Technical Service Bulletin: TSB200140

Released Date: 18-Dec-2025

Low Pressure Gear Pump and Lines

Figure 11, Existing Outlet Line Part Number 3688112 (Brown), Existing Gear Pump Part Number 4307482 (Gray), Priming Pump Part Number 3692468 (Green).

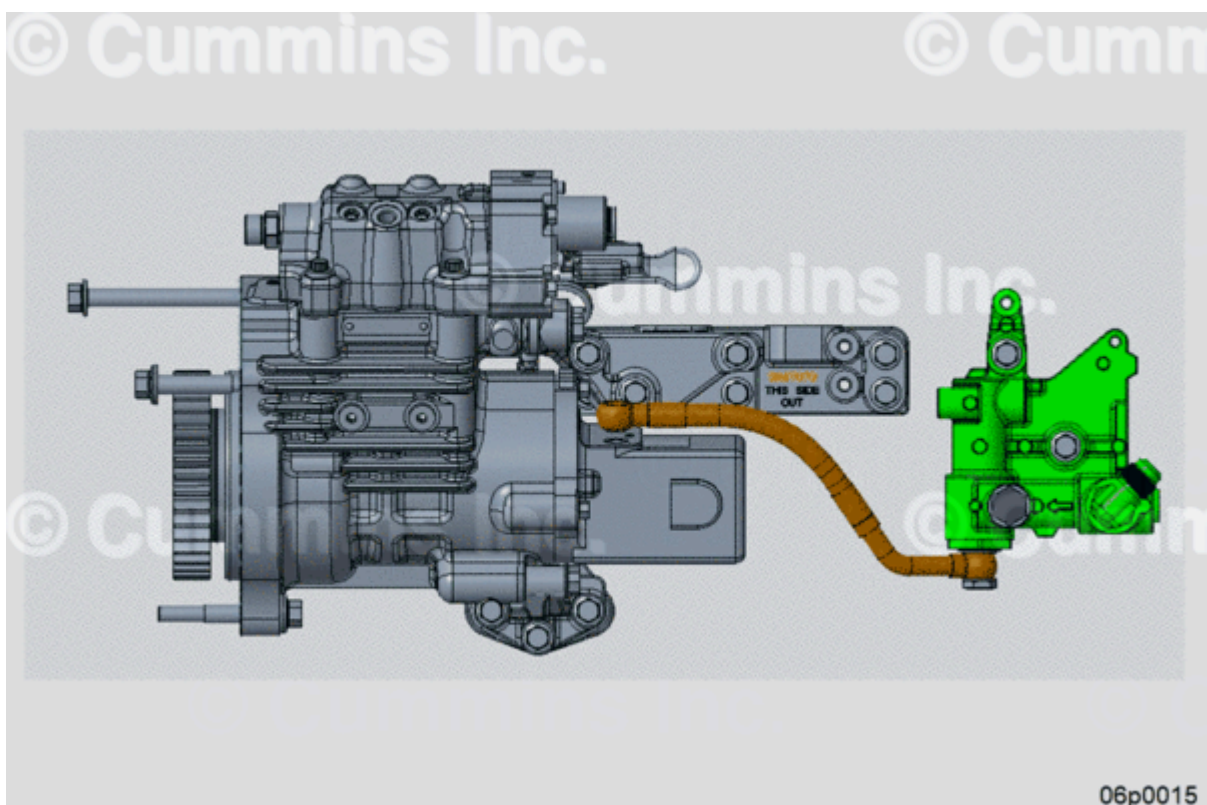
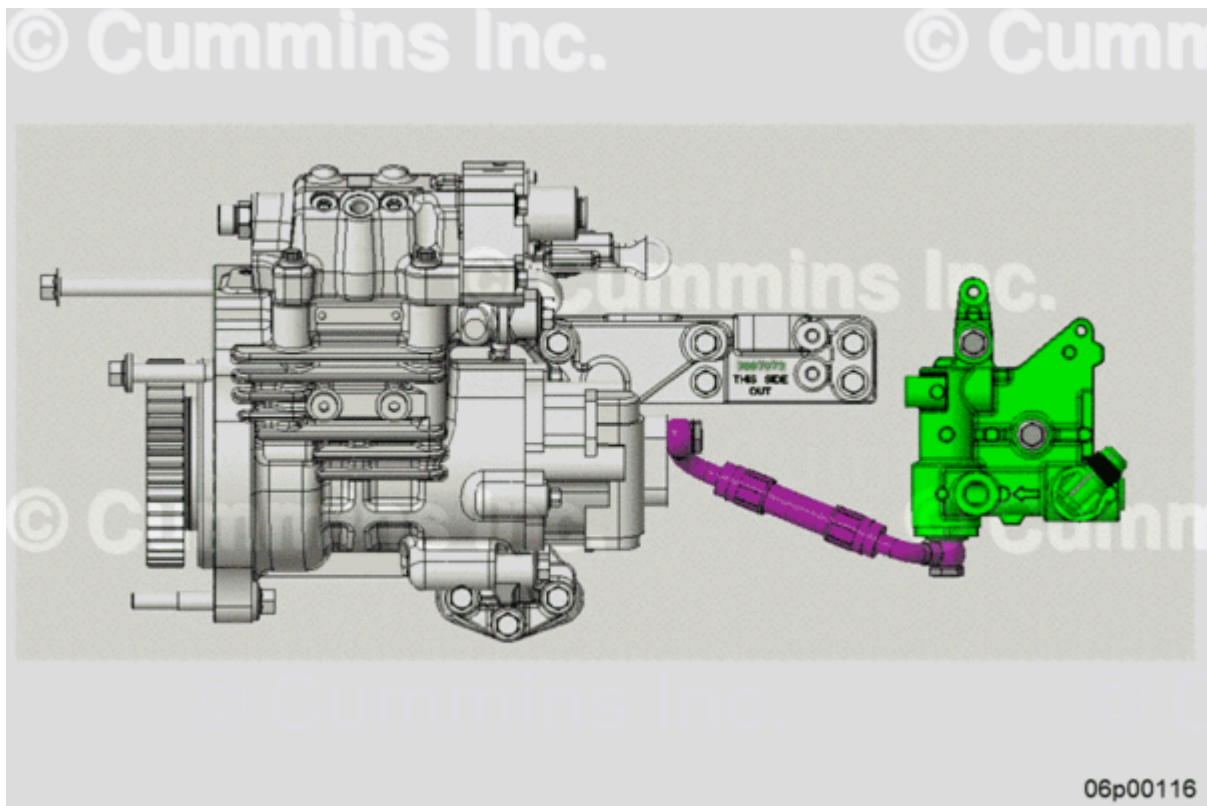
Figure 12, New Outlet Line Part Number 5575371 (Purple), New Gear Pump Part Number 5491782 (White), Priming Pump Part Number 3692468 (Green).

Figure 13, Existing Outlet Line Part Number 5558764 (Brown), Existing Gear Pump Part Number 4307482 (Gray), Fuel Filter Arrangement Part Number 3685850 (Green).

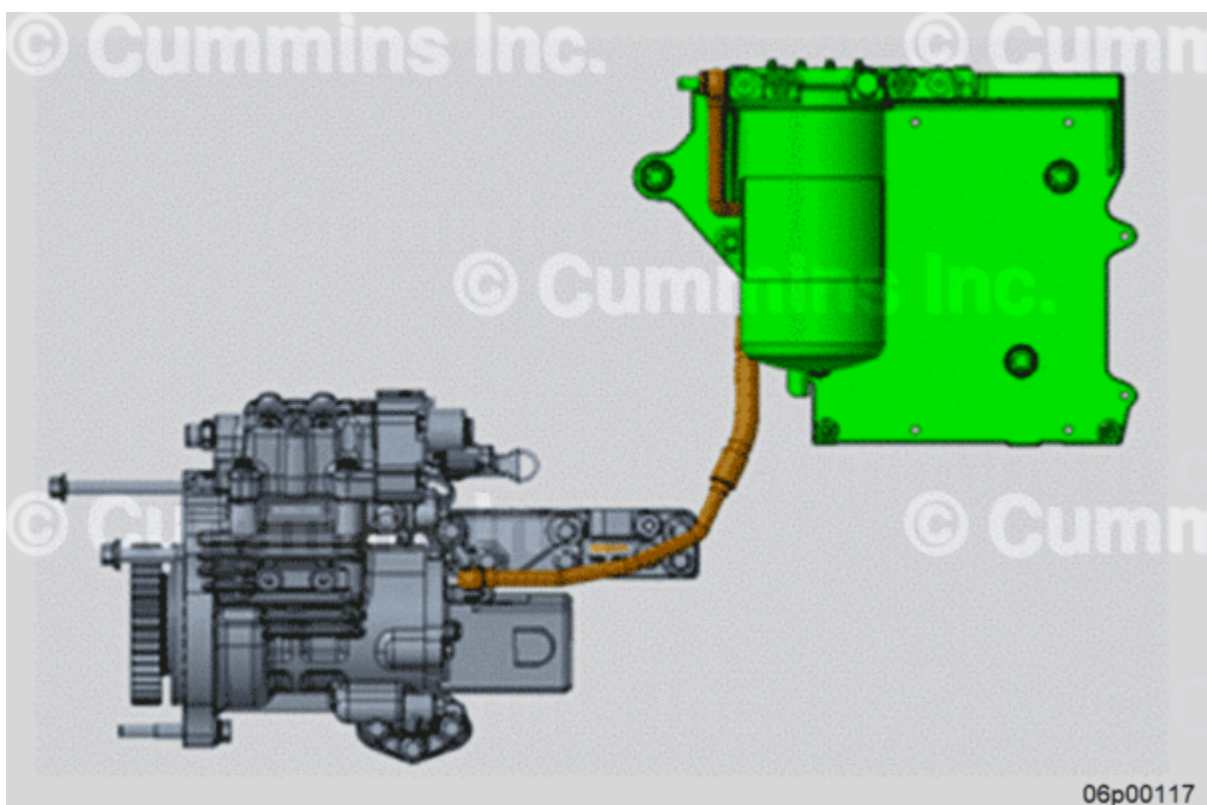
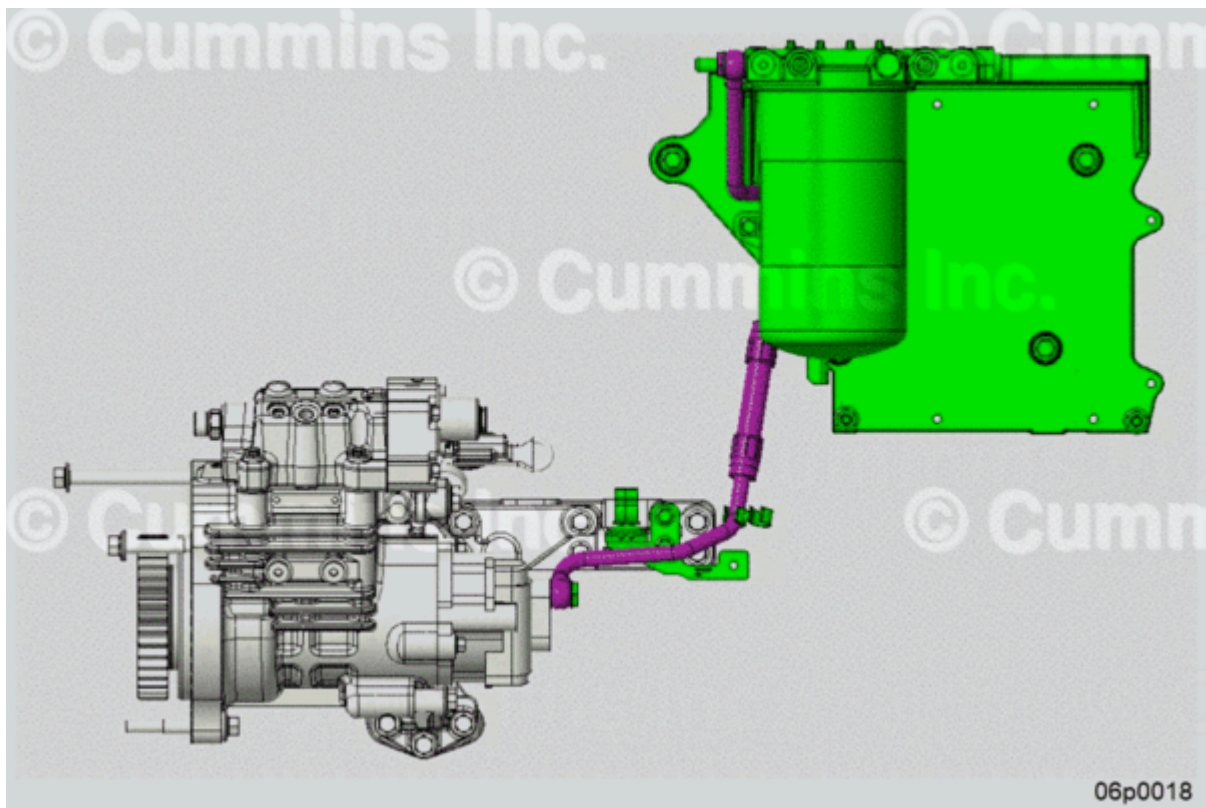
Figure 14, New Outlet Line Part Number 5575374 (Purple), New Gear Pump Part Number 5491782 (White), Fuel Filter Arrangement Part Number 3685850 (Green).

Figure 15, Existing Outlet Line, Part Number 3688398 (Blue), Existing Gear Pump, Part Number 4307482 (Grey), Fuel Filter Arrangement, Part Number 3685850 (Yellow).

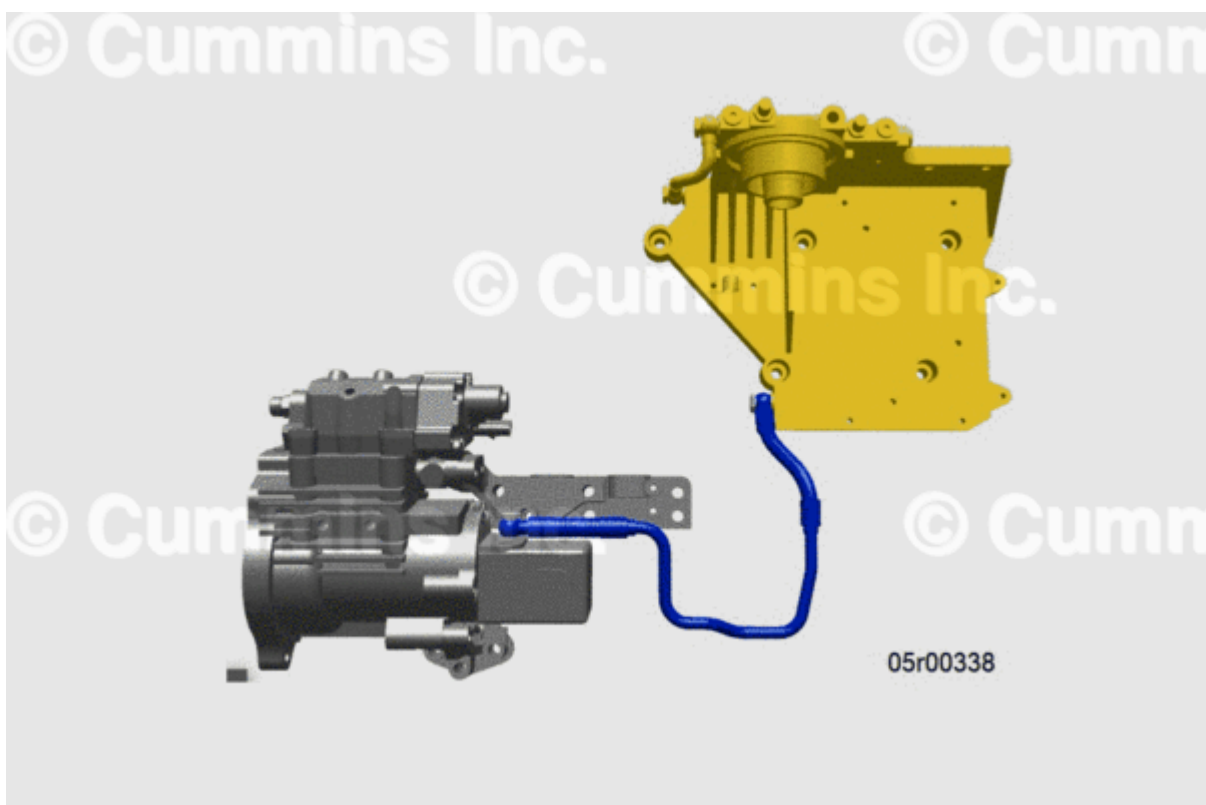
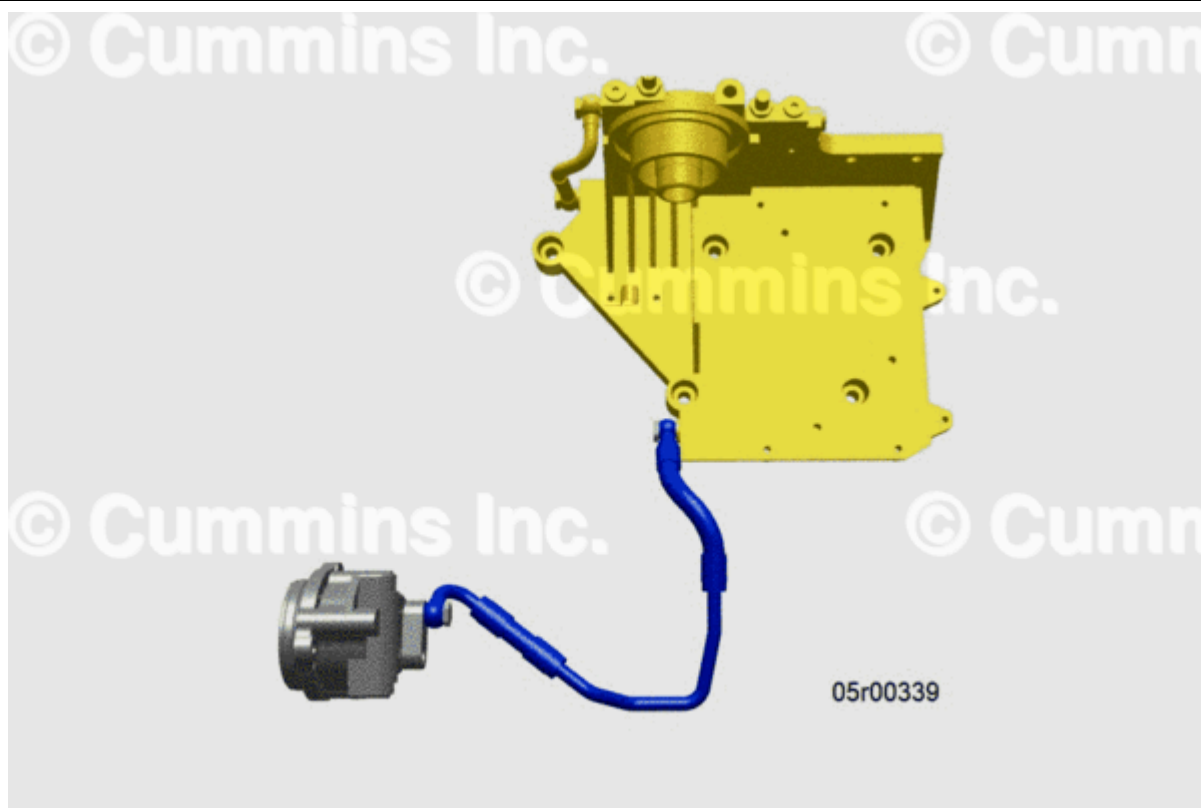
Figure 16, New Outlet Line, Part Number 5575373 (Blue), New Gear Pump Part Number 5491782 (Grey), Fuel Filter Arrangement, Part Number 3685850 (Yellow).

Figure 17, Existing Inlet Line Part Number 5481051 (Blue), Existing Gear Pump Part Number 4307482 (Gray), Priming Pump Part Number 5481052 (Green).

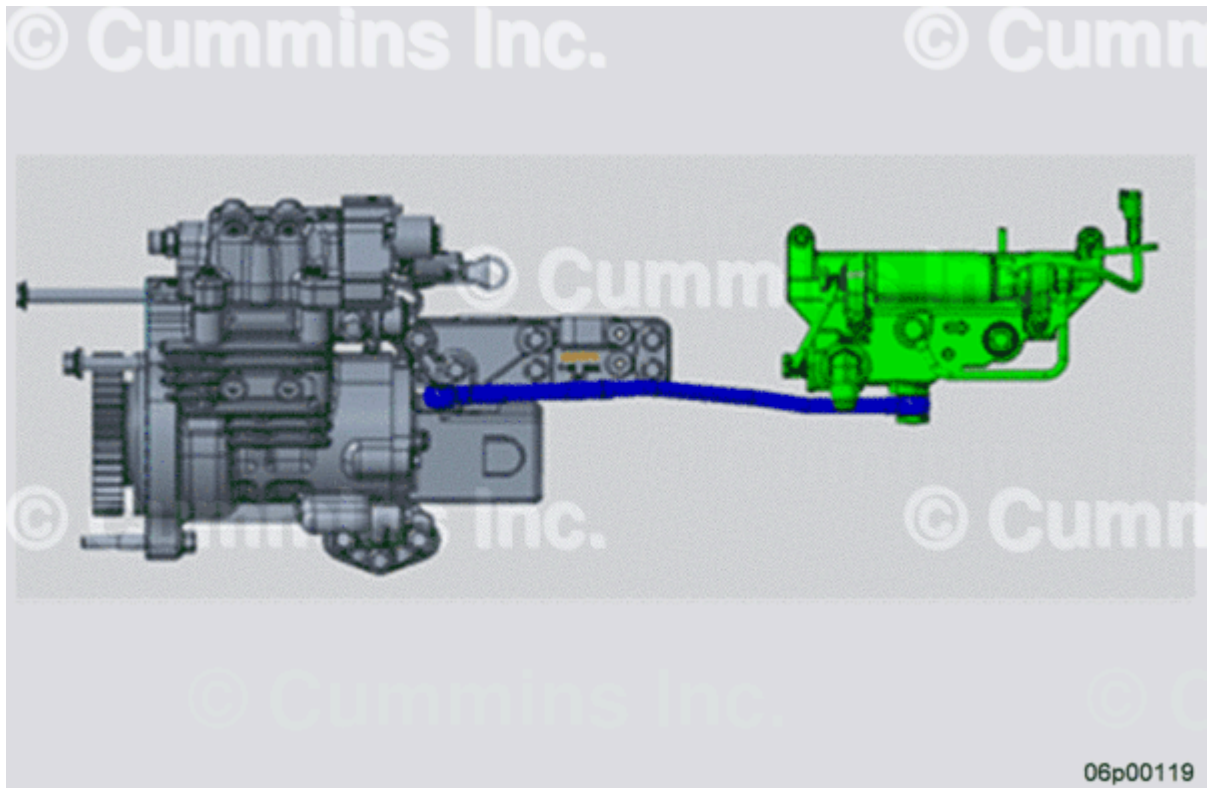
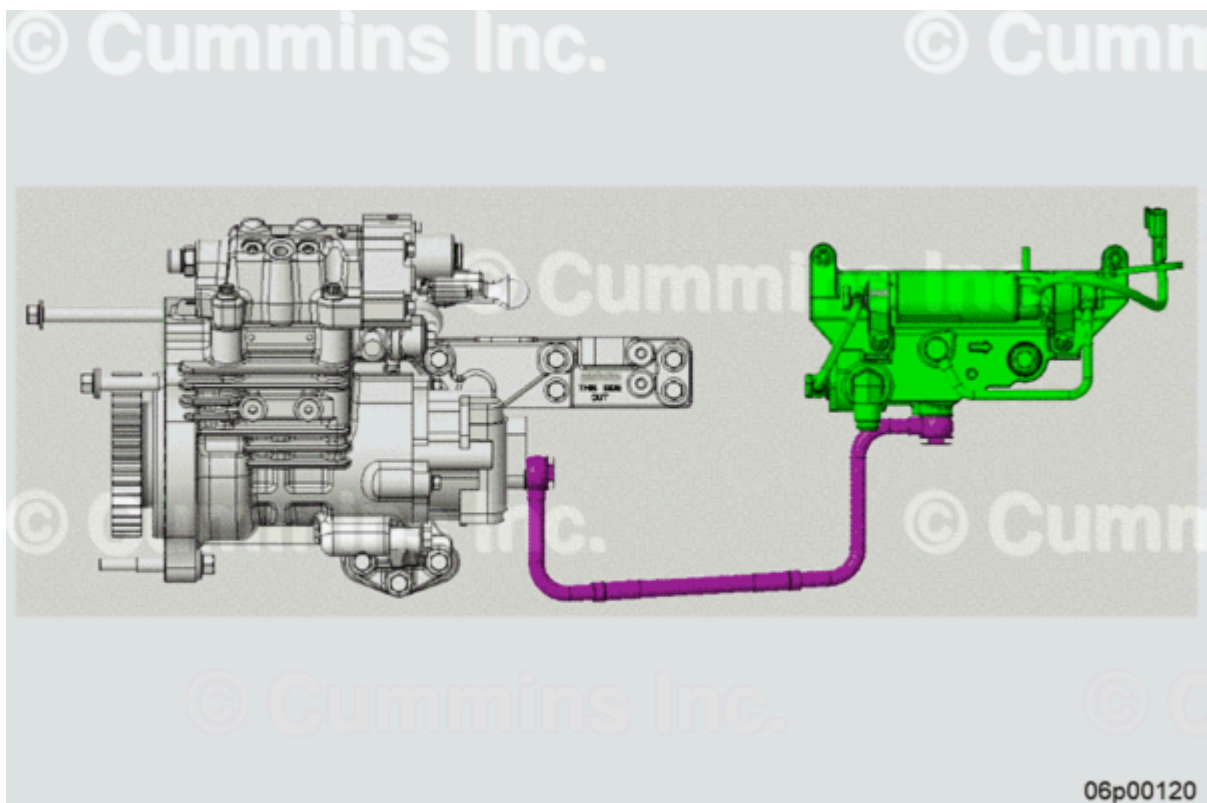
Figure 18, New Inlet Line Part Number 5566481 (Purple), New Gear Pump Part Number 5491782 (White), Priming Pump Part Number 5481052 (Green).

Figure 19, Existing Outlet Line Part Number 5481055 (Blue), Existing Gear Pump Part Number 4307482 (Gray), Fuel Filter Arrangement Part Number 3685850 (Green).

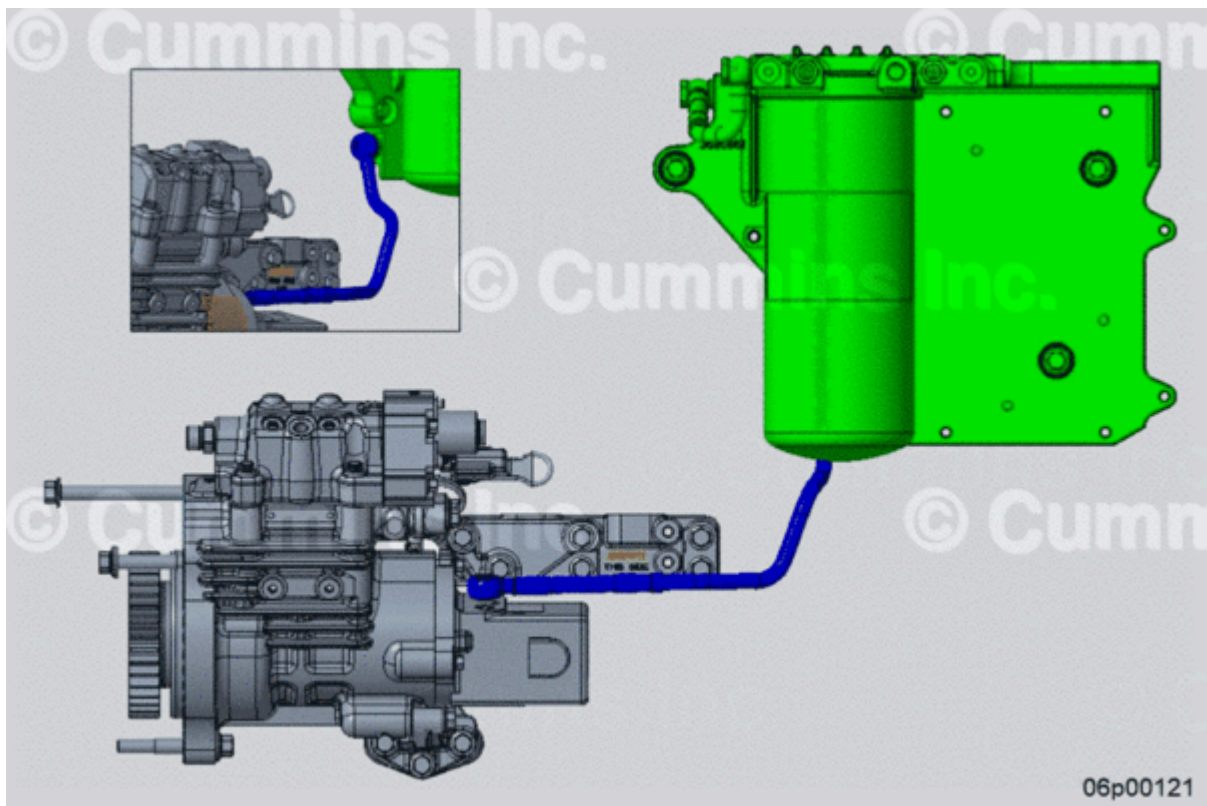
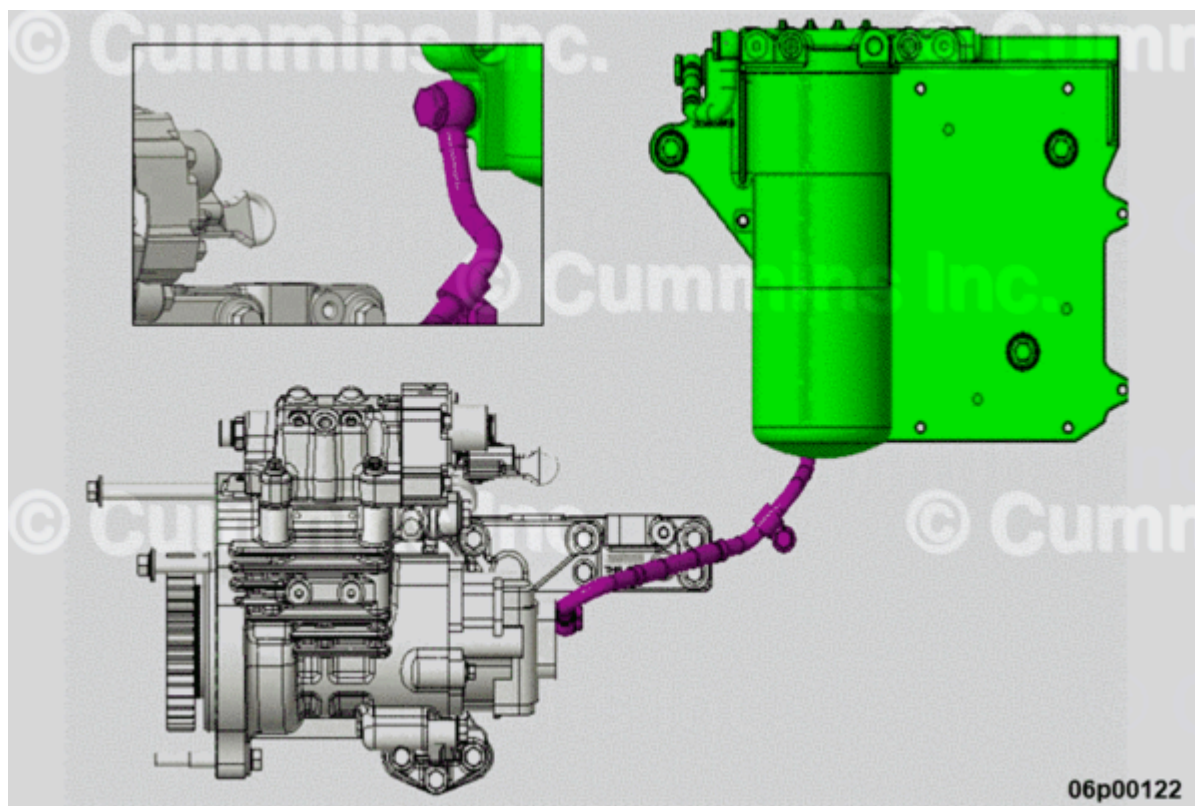
Figure 20, New Outlet Line Part Number 5566482 (Purple), New Gear Pump Part Number 5491782 (White), Fuel Filter Arrangement Part Number 3685850 (Green).
